ADDENDUM NO: 01

PROJECT: OC383X IU Innovation Center – Indianapolis – Innovation Center Building Envelope Updates

PROJECT NO: CSO - 2026050 DATE: 07/29/2026 BY: Nick Wissing

DRAWING TITLE:
FIRST FLOOR PLAN

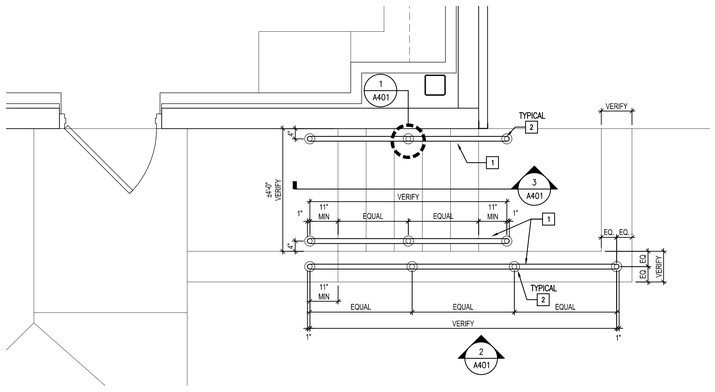
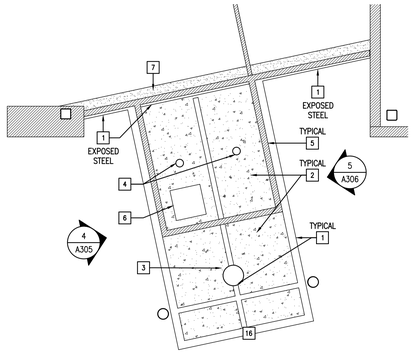
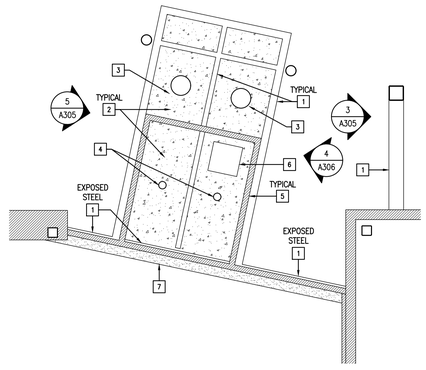
3.1 A201 – FIRST FLOOR PLAN

A. Modify Keyed Plan Note #1 to ALUMINUM railing.

B. Add Keyed Plan Note #8.

1. SECTION 057300 DECORATIVE METAL RAILINGS: NEW 1-1/2" NOMINAL DIAMETER (1.90" ACTUAL O.D.) ALUMINUM PIPE GUARD AND HANDRAIL. EMBED A MINIMUM OF 5" IN GROUT SUITABLE FOR EXTERIOR USE.
2. CORE EXISTING CONCRETE TO 4" ACTUAL DIAMETER AND TO 6" DEPTH TO EMBED AND GROUT IN NEW PIPE RAILINGS.
3. EXISTING CONCRETE RETAINING WALL TO REMAIN.
4. EXISTING CONCRETE SIDEWALK TO REMAIN.
5. EXISTING CURTAIN WALL TO REMAIN. SEE EXTERIOR ELEVATIONS FOR NOTES RELATING TO WORK SCOPE.
6. SECTION 099652 ELASTOMERIC COATINGS: PREPARE EXTERIOR FACE AND RETURN ENDS OF PRECAST CONCRETE SURFACE TO RECEIVE NEW ELASTOMERIC COATING. COLOR TO BE "SHERWIN WILLIAMS SW7593 RUSTIC RED"
7. PROVIDE FLOOR TO CEILING CONSTRUCTION BARRIER SEALED TIGHT TO EXISTING CONSTRUCTION.
8. REMOVE EXISTING STOREFRONT WINDOW SYSTEM. REMOVE AND SALVAGE HORIZONTAL LOUVER BLINDS AND REINSTALL UPON COMPLETION OF NEW WINDOW INSTALLATION.

DRAWING TITLE:
SECOND FLOOR PLAN

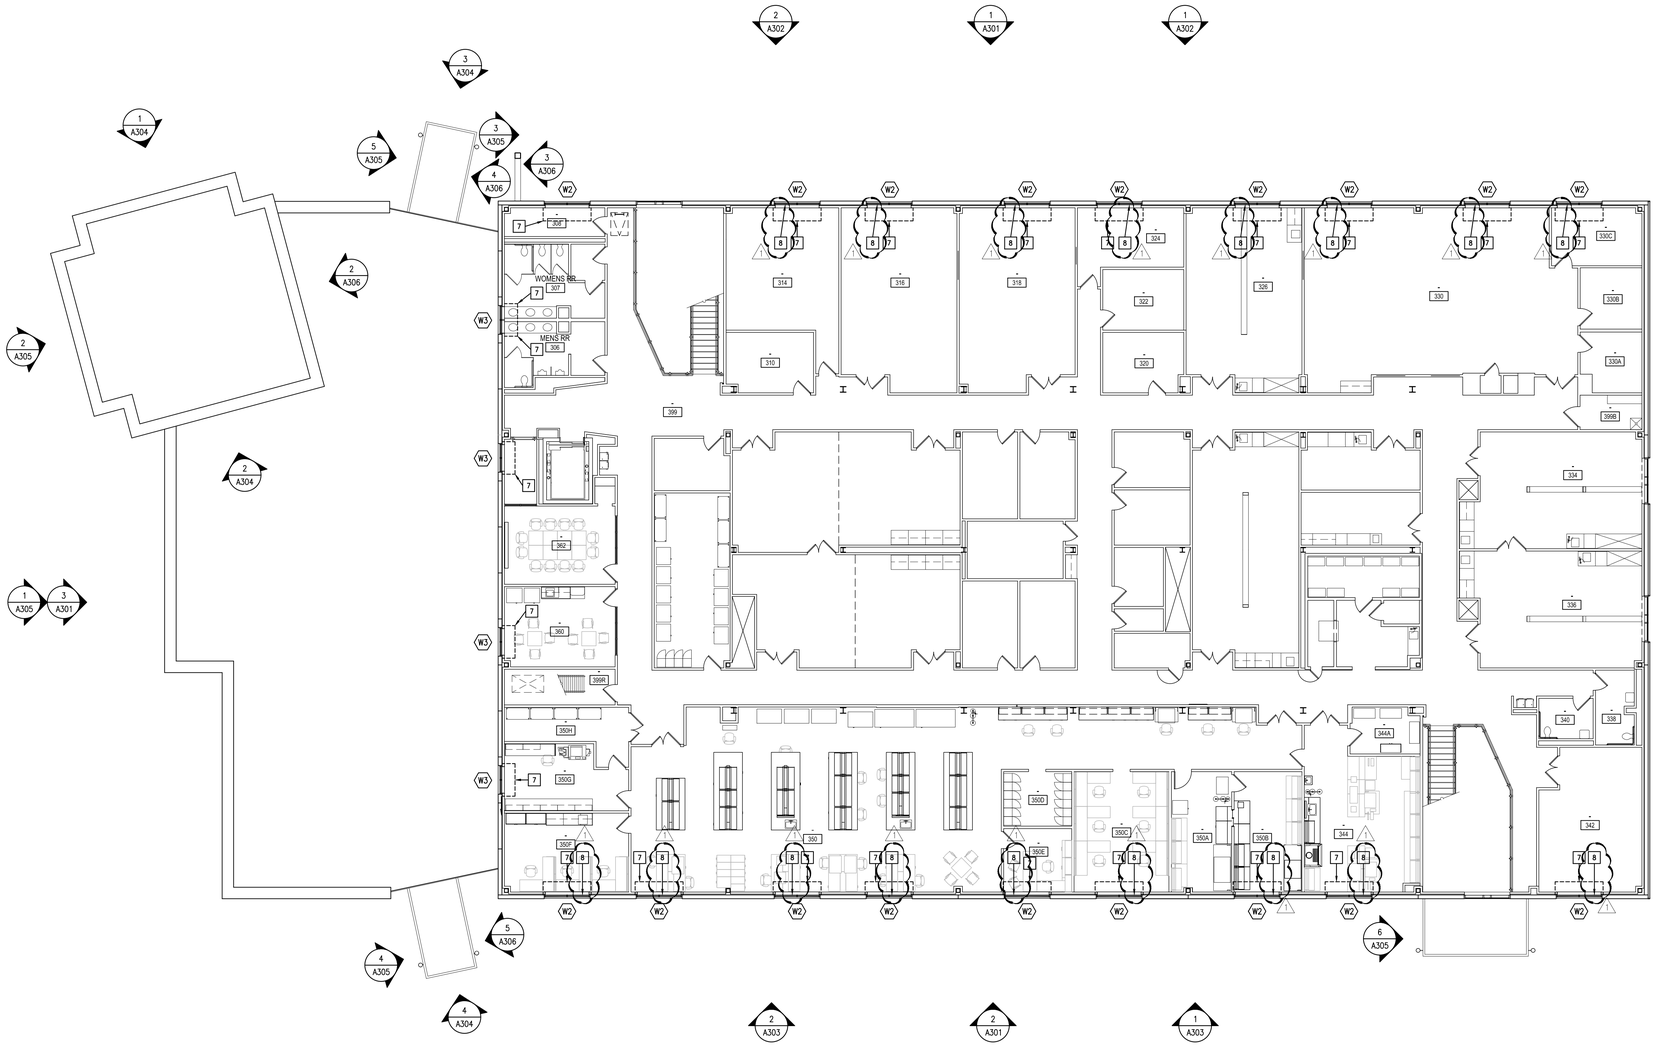
3.2 A202 – SECOND FLOOR PLAN

A. Add Keyed Plan Note #8
